Servo Valve Model No : 902HF-0038

Internal Amplifier Card Part No : 14-150X

Title: Specification2doc

Document No.: SHYD.57

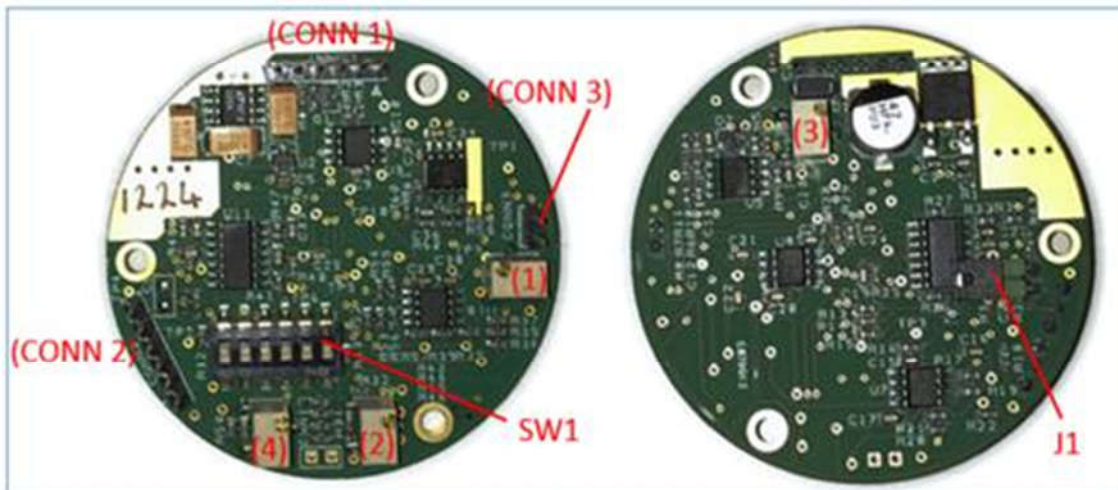
Integrated control card is modified as follows:

- (1) All potentiometers and large capacitor to be epoxied to PCB to improve vibration resistance.
- (2) Jumper 'J1' not to be fitted.
- (3) All potentiometer adjusters to be epoxied after final setup.
